RE: Request for Labeling and FCC ID display exemption
Applicant: Earlens Corporation
FCC ID: 2AGDU-EL1

From: oetech@fccsun27w.fcc.gov
Sent: Monday, February 08, 2016 12:20 PM
To: Krishna Vemuri Intertek
Subject: Response to Inquiry to FCC (Tracking Number 263437) (TCB)

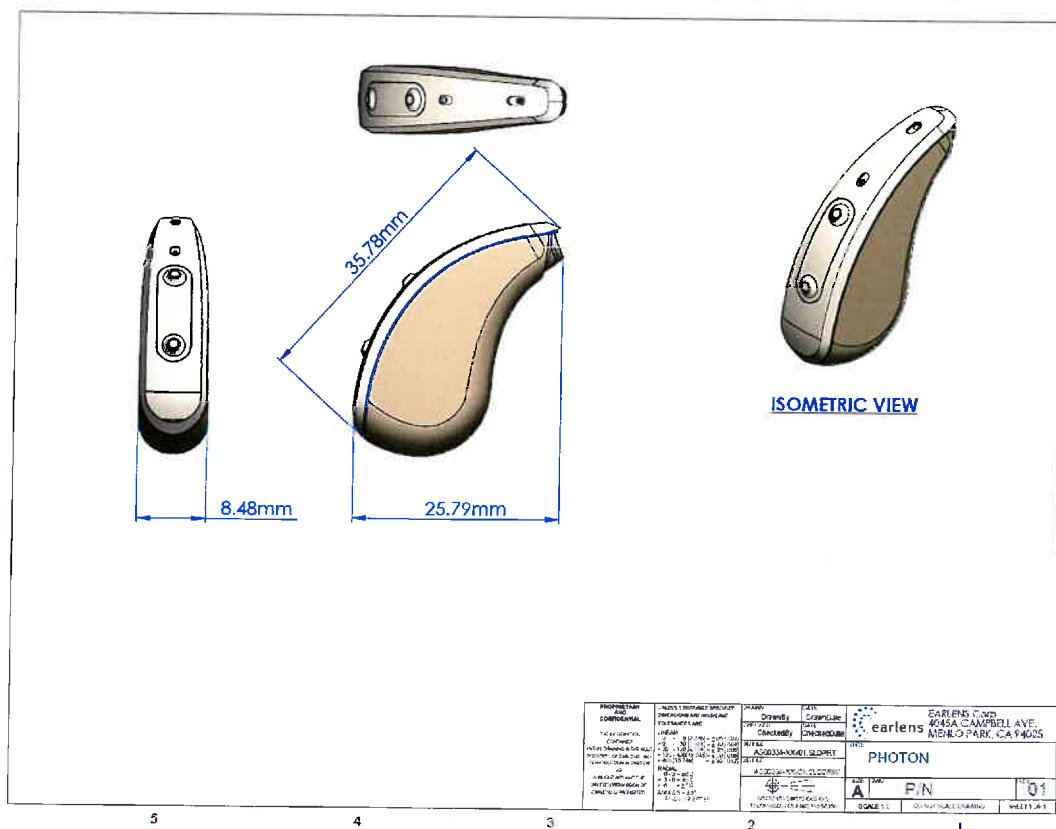
- The top cover and the bottom housing of the device are designed to be removable without using any tools. See attached photo of disassembled device with bottom housing on the left, electronics assembly in the center and top cover on the right.
- Because there are no permanent surfaces on the housing, the requirements defined in the 784748 D01 Labelling Part 15 & 18 Guidelines, Section 4. Label Location for Part 15 and 18 Devices do not apply to our design.
- We believe the products referenced below constitute a precedent to our request.
 - Resound X26BE70
 - Starkey EOA-IRIS-HA

With regard to the FCC ID on the device, it is unclear what the dimensional units are on the exhibit provided. Also, indicate whether or not there will be any markings or notices at all on the outside of the device and if so, provide photo's of them.

There appears to be enough space on the device specifically on the bottom side which has markings on it. Lack of space is not justified when other markings are on the device. It appears the FCC ID can be placed next to or in lieu of one of the other markings.

The FCC identifier can be placed in the area where there is the "Earlens" and some serial number. It cannot be justified that it cannot be done when it has been done albeit with other markings or when other markings take up the space.

The applicants letter and justification is acceptable. The FCC ID label can go in the manual for this device.
Thanks.
